Technical Service Bulletin

87 Faint noise heard in cabin from air conditioning circuit

87 19 93 2044717/9 July 12, 2019. Supersedes Technical Service Bulletin Group 87 number 18-86 dated April 9, 2018 for reasons listed below.

| Model(s) | Year | VIN Range | Vehicle-Specific Equipment |

Figure 4. The low side line that needs to be replaced.

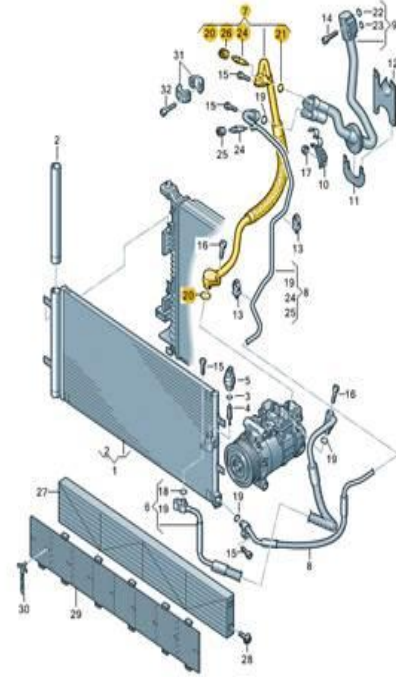
3. Replace the low side refrigerant line that connects the air conditioning compressor suction port to the hybrid refrigerant line to the expansion valve (Figure 4). Be certain to use new O-rings at these and all refrigerant circuit joints that are disconnected.

Figure 5. Balance weight position on the low side line.

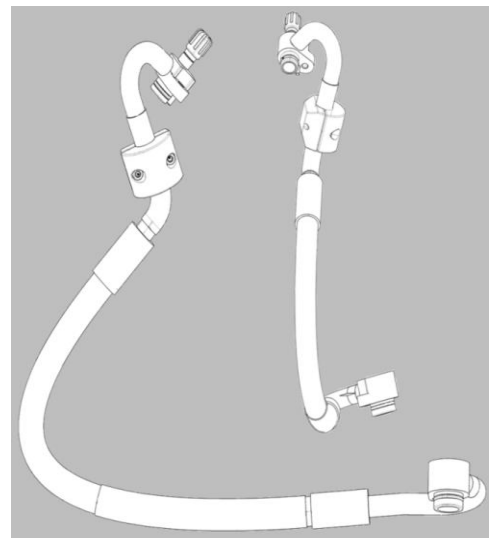
4. Install the balance weight (part number 4G0513621A) with 2 bolts (part number N 10653601) to the line in the position shown in the illustration (Figure 5).
